**From:** Kiefer, Sharon [sharon.kiefer@idfg.idaho.gov]  
**Sent:** Wednesday, April 14, 2010 6:38 PM  
**To:** Lemont, Stephen; bmbiwer@anl.gov  
**Cc:** Hebdon, Lance; Vecellio, Gary  
**Subject:** IDFG Response to NRC AREVA Supplemental Request  
**Attachments:** E-mail from NRC to Sharon Kiefer regarding additional AREVA project information 2-10-2010.txt; Response to NRC AREVA transmission supplemental request Mar 2010.docx

The Idaho Department of Fish and Game (Department) is providing this information in response to a February 10, 2010 request by Stephen Lamont of the Nuclear Regulatory Commission (NRC) to Sharon Kiefer. These items are provided in supplement to the responses provided by the Department on August 4, 2009. This response incorporates potential issues related to a power line to service the infrastructure, which was not identified in 2009.

Figure 1. Location of sensitive species records from the IDFG Natural Heritage database and Sage-grouse habitat in proximity to the proposed AREVA transmission line.

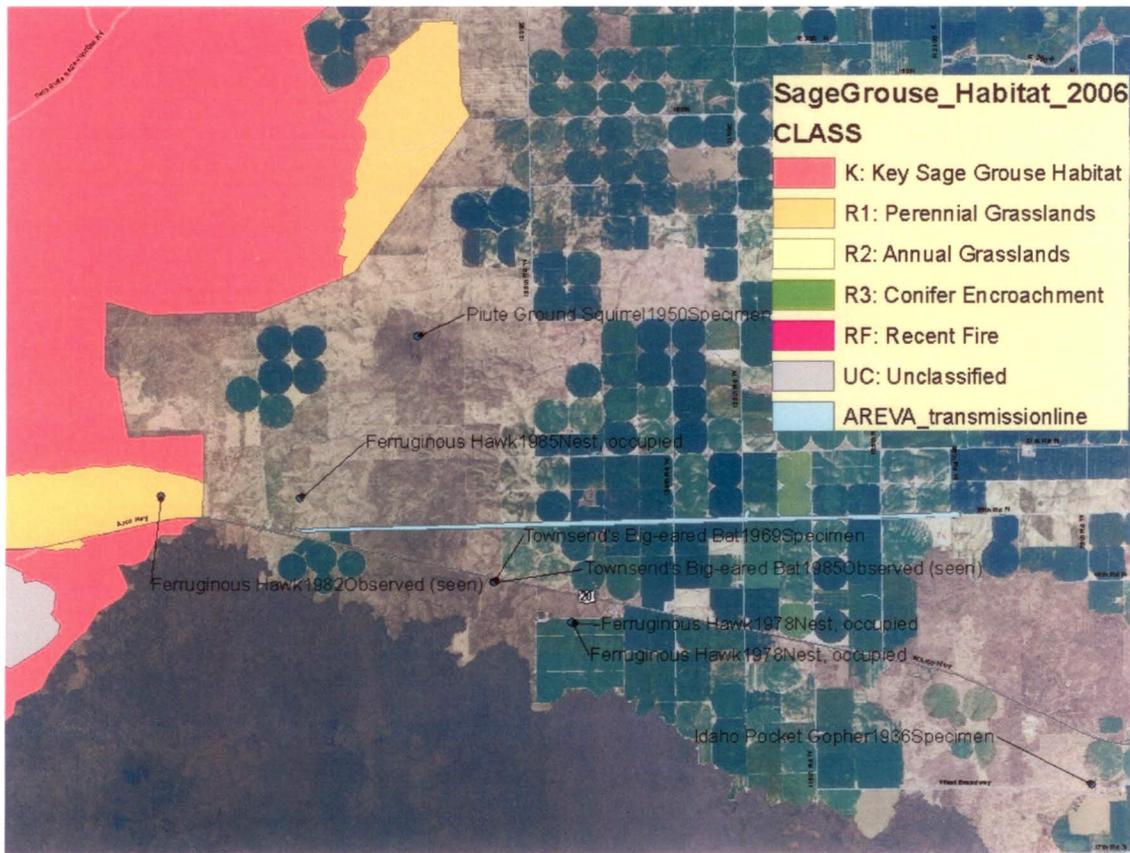
Department staff considers the areas both north and south of your proposed power line to be important habitat for lek development, rearing, and migration of sage grouse. It is likely that a new above-ground transmission line will cause direct mortality of migrating sage grouse due to grouse striking the lines during flight. The locations of sensitive species from the Idaho Natural Heritage Database and occupied sage-grouse habitats in the vicinity of the proposed right-of-way for the power line are depicted in Figure 1. Department staff is unaware of any federally-listed species within the bounds of the project.
